## Technical change to RS 32IO 3W L H S module

9445970000 RS 32IO 3W L H S

PCN-number: 20231227

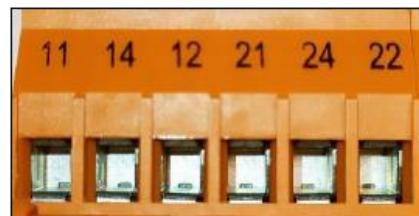
Article on Section 5 was delivered in the past with LP3R 5.08 connectors marked with Dekafix\*

\*Dekafix is the universal marker for terminals, plug-in connectors and electronic modules from the Weidmüller product range (see detail).

Based on continuous improvement, the LP3R connectors mentioned in Section 1 will be replaced by LL3R 5.08 connectors. Furthermore, the LL3R connectors will be marked with Tampoprint.

RS 32IO Interface (w/ LP3R and 4066510000 Box Header Male connector)

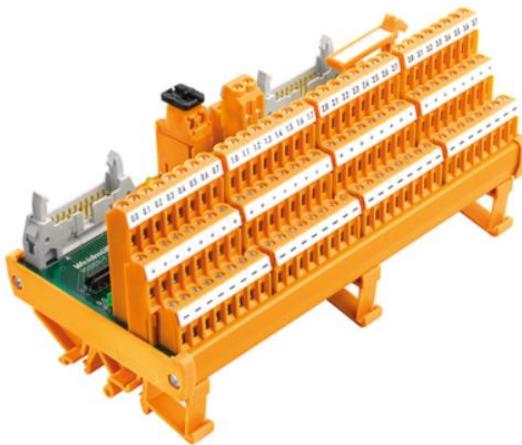
In addition, the article was delivered with 4066510000 Box Header Male 20P connectors.

Obsolescence of LP3R and 4066510000 Box Header Male connectors.

Additionally, 4066510000 Box Header Male connector will be replaced by 1476790000 Box Header Male connector.
